Pearl Place

30th and Pearl Street, Boulder CO

Site Review

LUR2014-00035

September 15, 2014 site Submittal

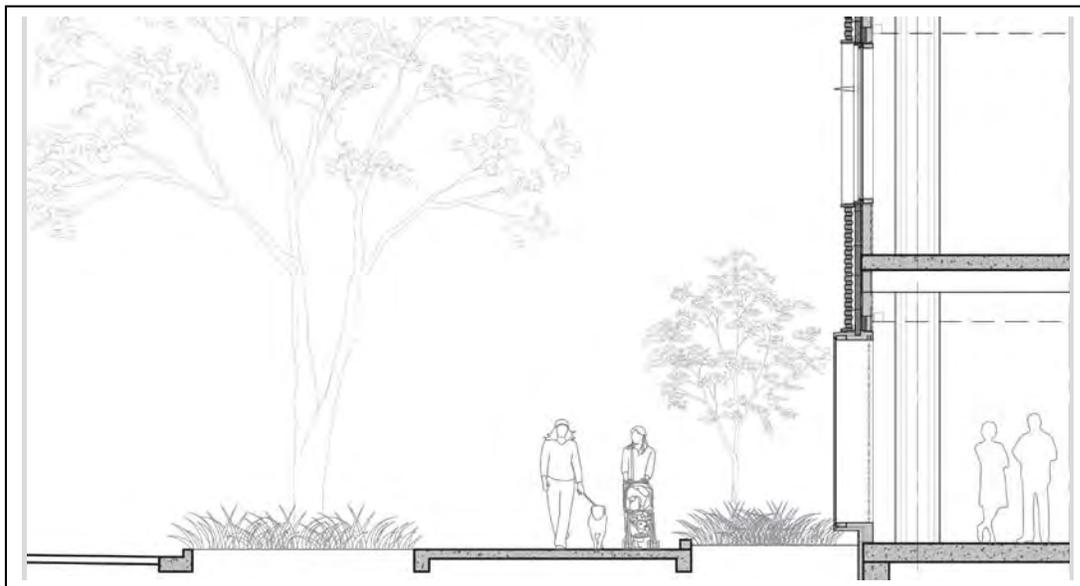
As shown below, the street elevation for Pearl Street, especially within the critical first floor has 100 linear feet with just one street level window. This elevation must be revised to illustrate window openings on the ground level. Illustrate this elevation with a perspective sketch as well.

**Submittal
September 15, 2014 site Submittal**

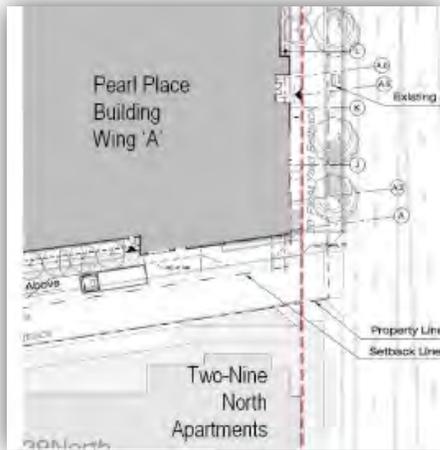
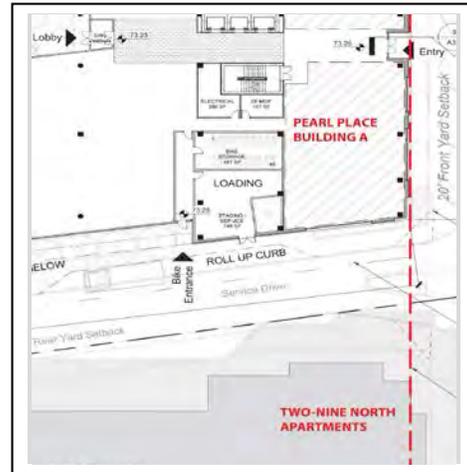
5. As shown to the right, the Two-Nine North Apartments to the south of the site are moved closer to the property line. The proposed buildings should at least be similar in proximity, or provide detailed information on how the project addresses the pedestrian experience along 30th Street.

The building edge adjacent to 29 North is in proximity to the second step in the corner volume (nor the first). This second step represents the taller set of volumes at the corner of this building and is of a more appropriate scale when considering the volume of the office. We believe this alignment better creates the sense of a "gateway" intended by the comment.
